New Albany Planning Commission
Monday, November 18, 2024 Meeting Minutes - Approved

VAR-61-2024 Variance Reconsideration Request

ZC-71-2024 Zoning Change

REAR ELEVATION

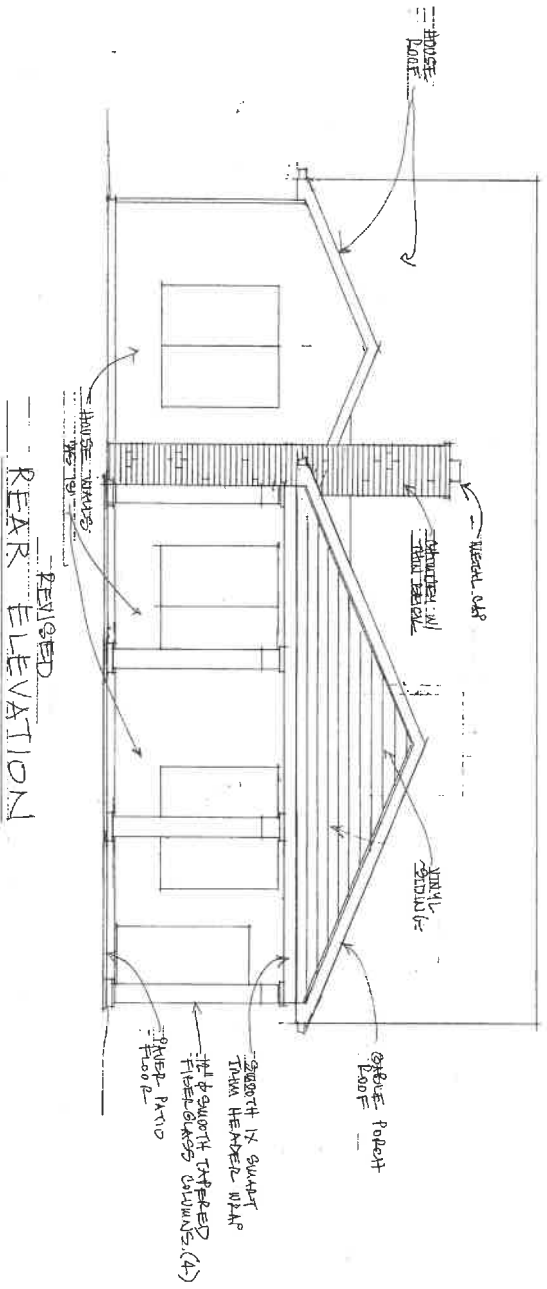
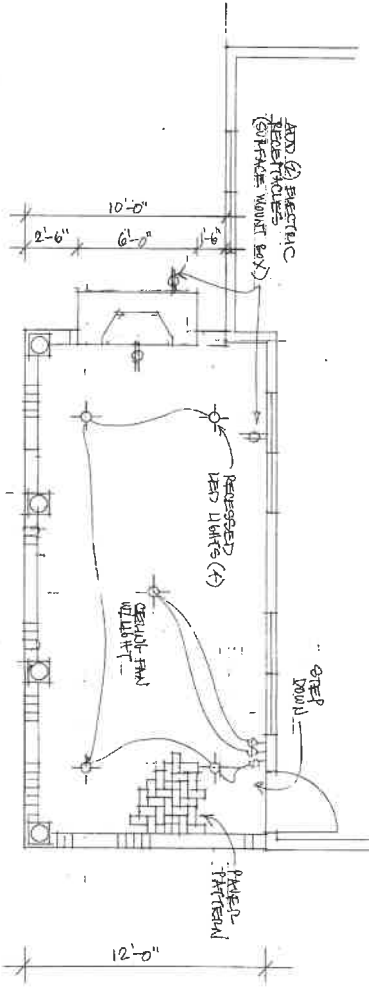
Since receiving the denial, circumstances affecting the subject property have substantially changed. The plan for the proposed porch has been revised to locate the proposed fireplace chimney (2 feet in depth) to the left side of the porch, instead of extending 2 feet into the back yard. *See* Revised Plan, attached as Exhibit C. Under the revised plan, the chimney will be brick, as the Commission requested. The original application incorrectly stated that “[t]he rear of the house is located 36.97’ from the rear lot line.” Exhibit A, p. 3 (unnumbered) at ¶ 3. This measurement did not take into account the 2’ recess in the exterior wall at the rear of the house where the covered porch would be located. The measurement from the rear lot line to the exterior rear wall of the house (where the porch would be located) is 38.97 feet. There is a 35-foot special rear yard setback. “Decks, patios, and screened porches may encroach a maximum of 6 feet into the minimum required rear yard setback.” Zoning Regulation E(6). “The Zoning text for the subdivision does say for all decks, patios and screen porches, so it’s covered or uncovered, we believe that this regulation would apply.” *See* excerpt of Sept. 16, 2024 Hearing Transcript, attached as Exhibit D, p. 4. Therefore, 3.97’ of the backyard is outside of the setback. The revised plan requests a variance of 2.03’.

Master Grading Plan

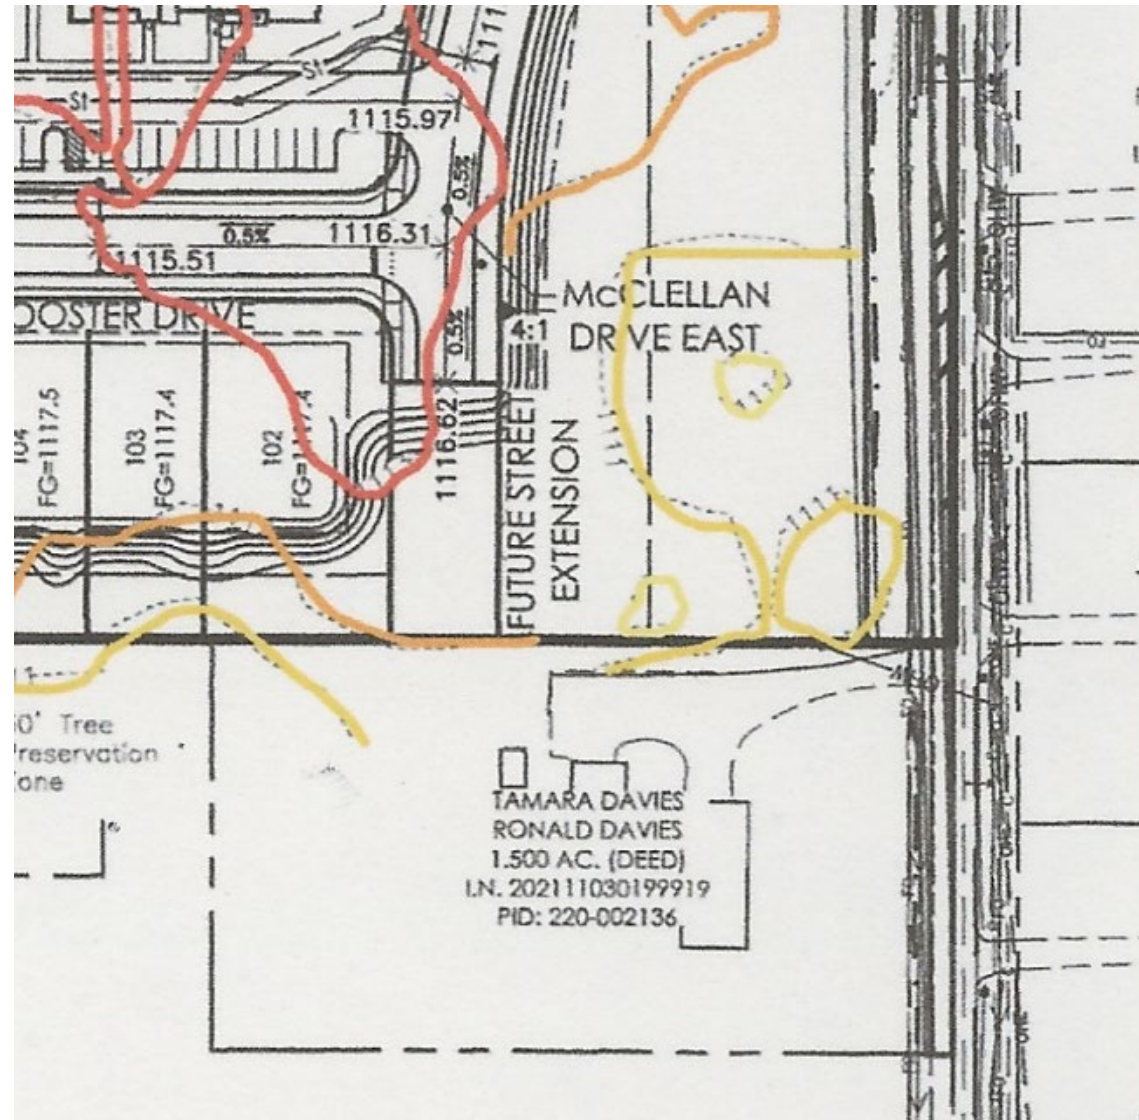
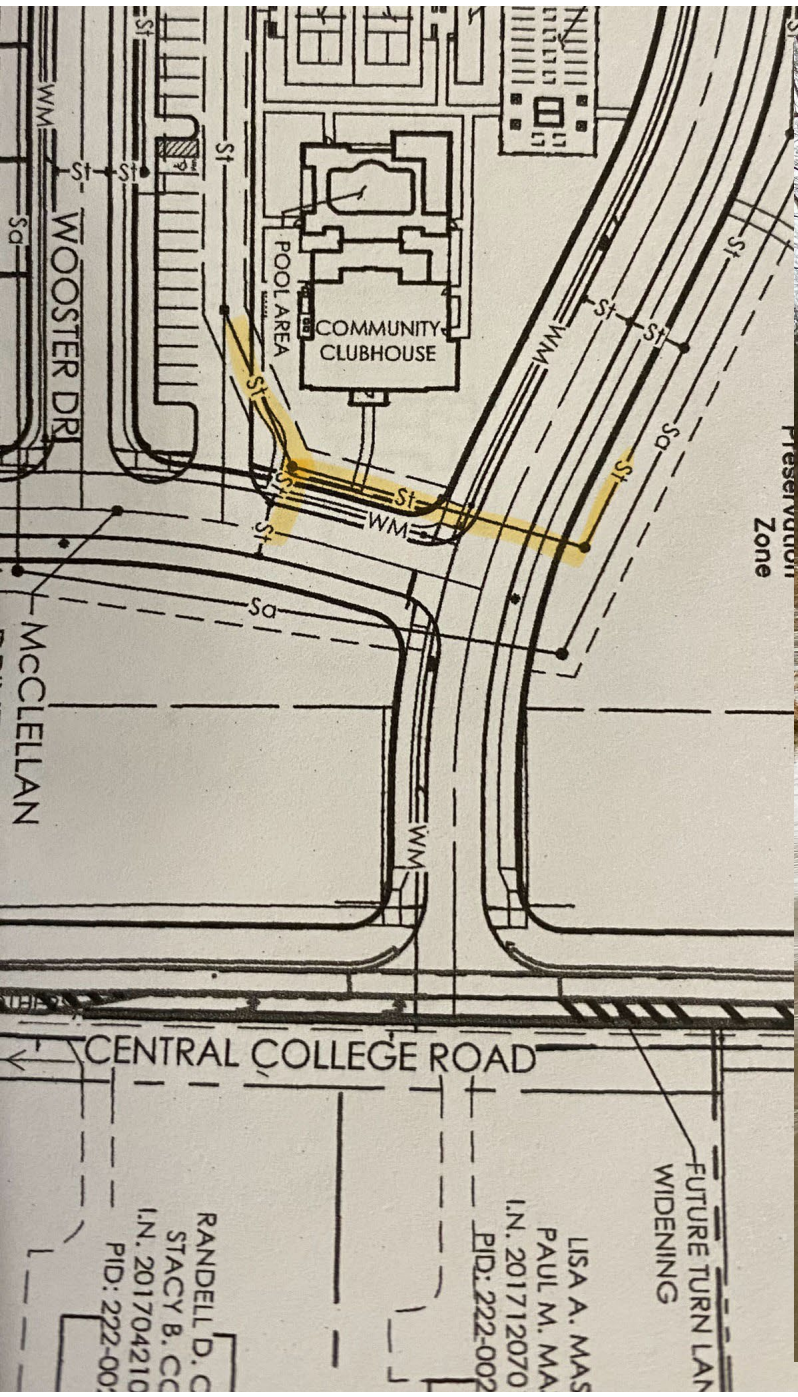
The base of the home on lot# 102 will be 7 feet higher than the home at 8238 Central College

The road stub will be 7 feet above grade for our home at 8238 Central College Rd. This disparity negatively effects the home's value.

Who has measured current drainage?
